To: Edie Berghoff, Associate Planner
From: Michael Bateman, PE, Development Review Engineer
Subject: Crystal View Post Decision Review
Date: December 10, 2018

The Crystal View Post Decision Review/Plat Modification, Planning File P-06-18-18-01 was received and reviewed by the Engineering and Public Works departments. The following memo provides Engineering and Public Works comments and conditions on the proposed modifications.

Geotechnical Report Addendum No: 3:
Stormwater Detention Vault
Proposed Crystal View Residential Plat
Poulsbo, Washington
PN: 24260130512009, 2426013004007
Doc ID: CrystalViewLLC CrystalView.RG.A(3)

TITLE CRYSTAL VIEW PLAT MOD
VAULT SECTIONS

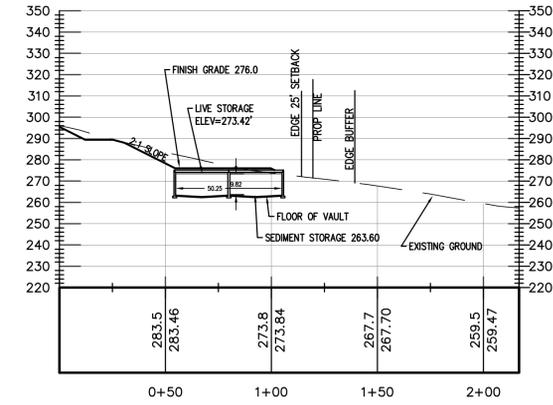
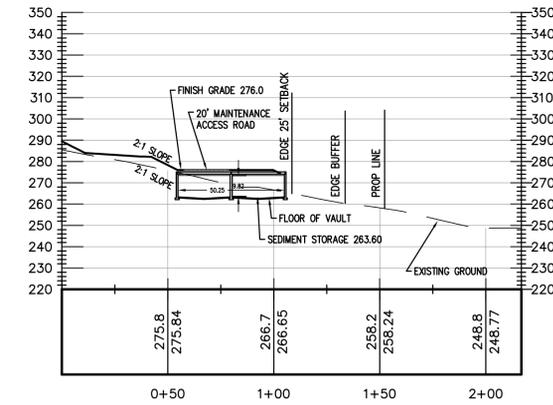
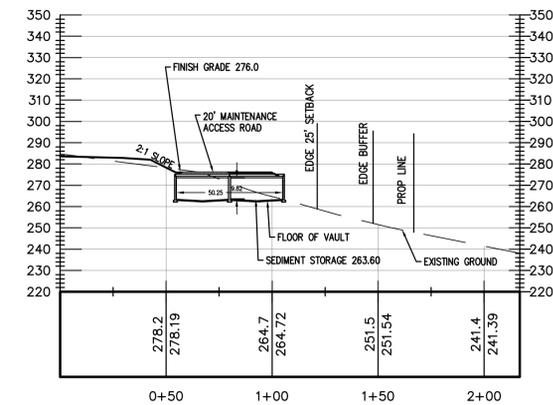
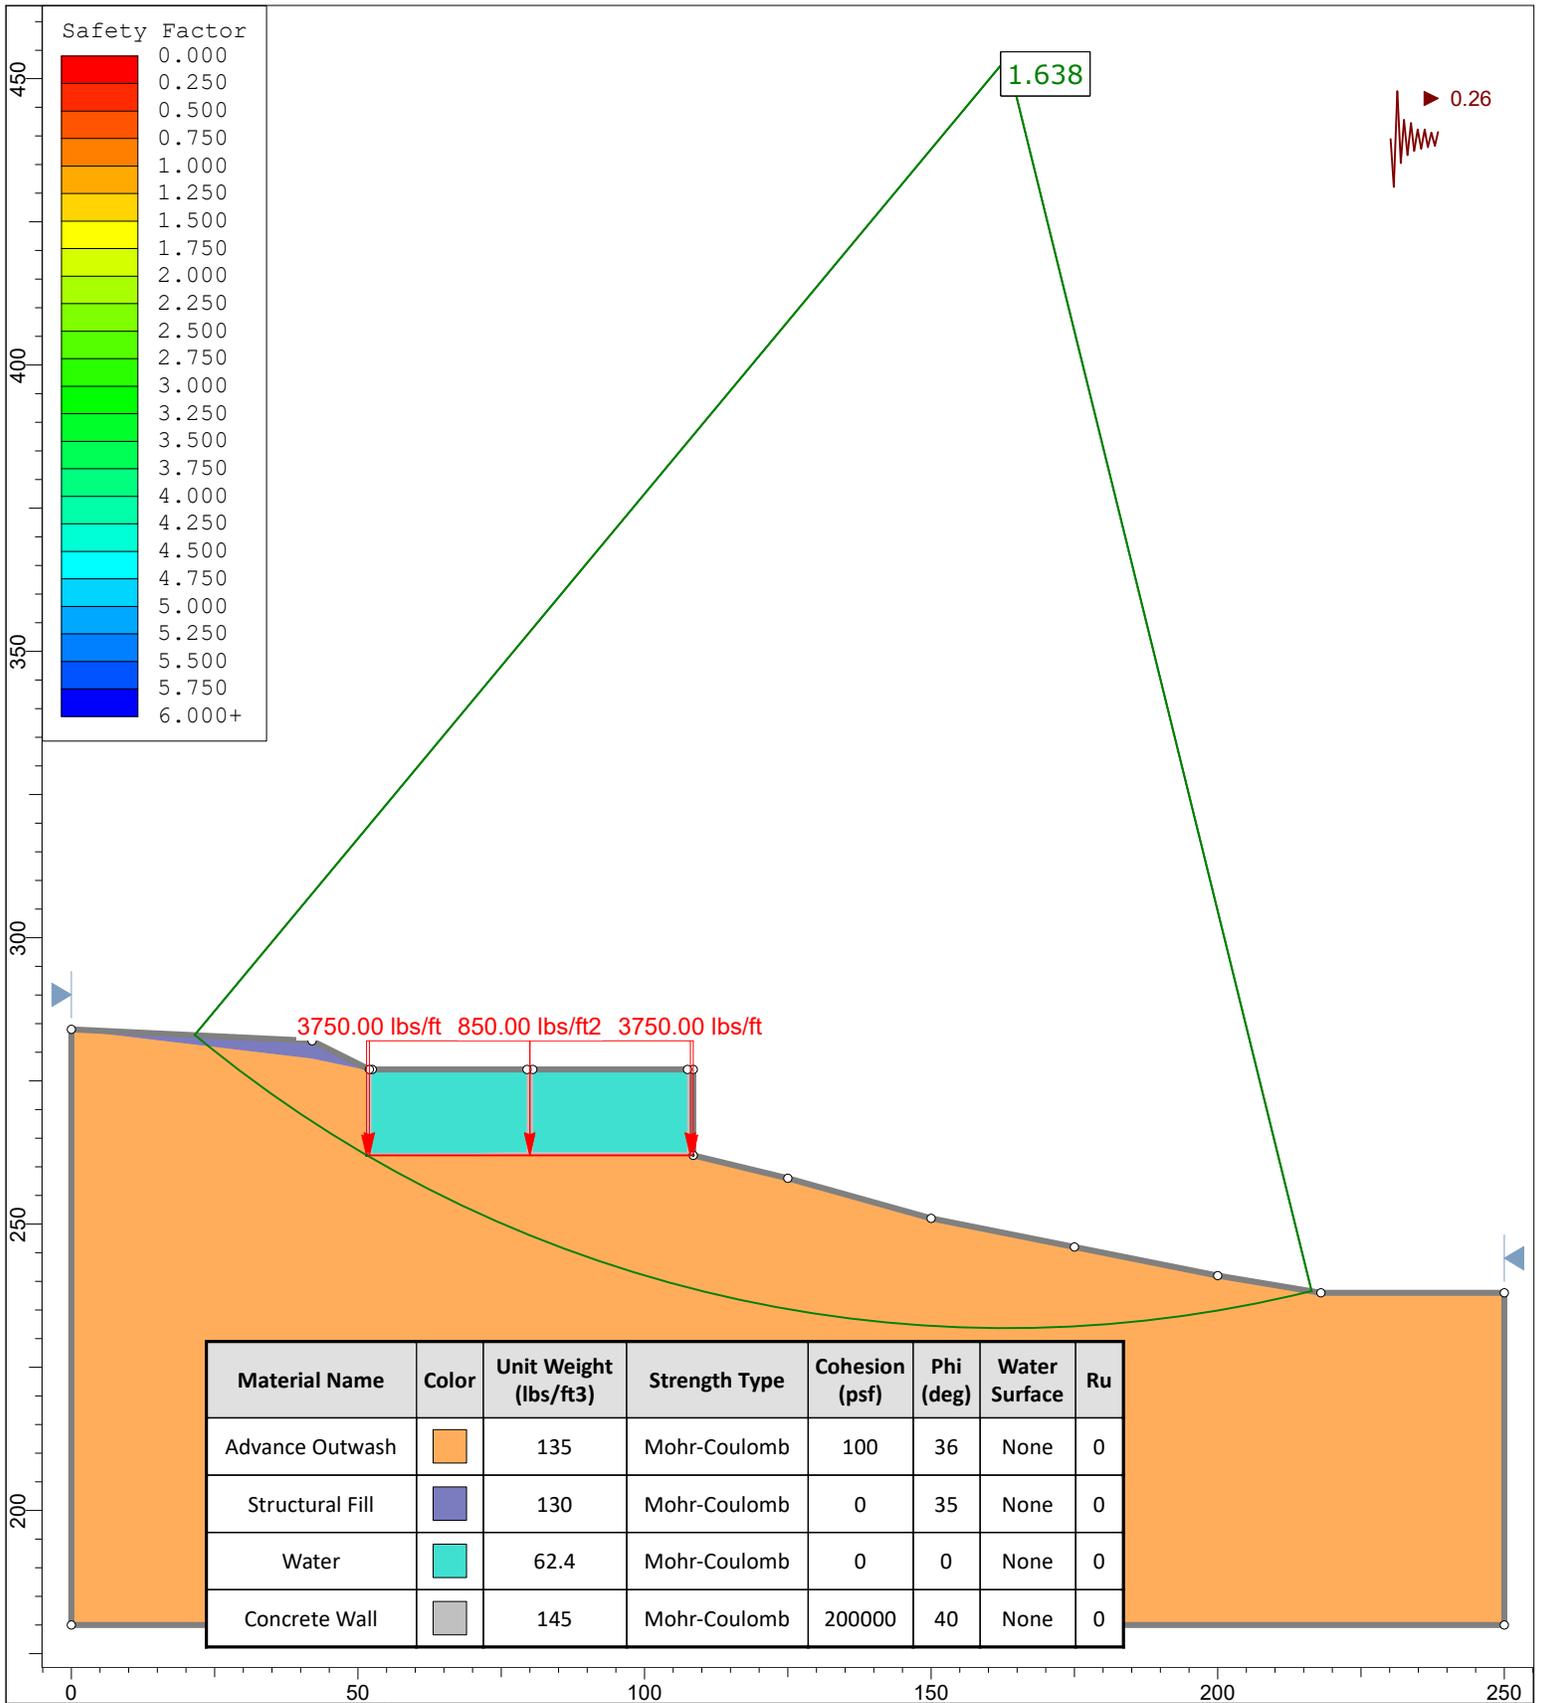
Team 4 survey and plan, slopes down to off-site stream at about 13 to 27 percent with the slope having a vertical height of 15 to 30 feet. The edge of the vault is proposed to be setback about 3 to 15 feet with an excavation of 2 to 12 feet in order to achieve design grades. The slope below the vault and temporary slope required to install the vault is shown on the attached vault sections.

Section 1808.7 requires a building setback from slopes that are steeper than 3H:1V (Horizontal: Vertical) or 33 percent with greater than 10 feet in vertical height, unless evaluated and reduced and/or a structural setback is provided by a licensed geotechnical engineer. The setback distance is calculated based on the vertical height of the slope. The typical 2015 IBC setback from the top of the slope equals one third the height of the slope, while a setback from the toe of the slope equals one half the height of the slope.

As stated above, the slope below the vault is flatter than 33 percent and therefore doesn't require special setbacks in order to satisfy section 1808.7 of the 2015 International Building Code (IBC). Although not required by the IBC, given the height of the vault and amount of storage capacity, we recommend a minimum setback (actual or structural) of 5 feet. Given the current design, the foundations for the vault appear to meet or exceed this 5-foot setback.

According to the three cross sections through the vault, the vault foundations will not encroach into the stream buffer or 25-foot stream buffer building setback. Additionally, most of the the vault excavation, including temporary cut slopes, will not encroach into 25-foot stream buffer building setback. However, the northern portion of the vault, as shown on Vault Section 1+50 will require a temporary excavation of 12 feet in depth, with about vertical distance of 8 feet from the outside edge of the vault foundation to the 25-foot stream buffer building setback. As stated in our original report, the upper 5 feet of the site soils are classified as Type C soils, while the deeper, glacially consolidated soils are classified as Type A soils. This will require the temporary excavation to encroach into the 25-foot stream buffer building setback. Our understanding of the code is that no structure can encroach into the building setback, but some grading and excavation is allowed. By the middle of the vault (section 0+75), the temporary excavation will not encroach into the building setback.
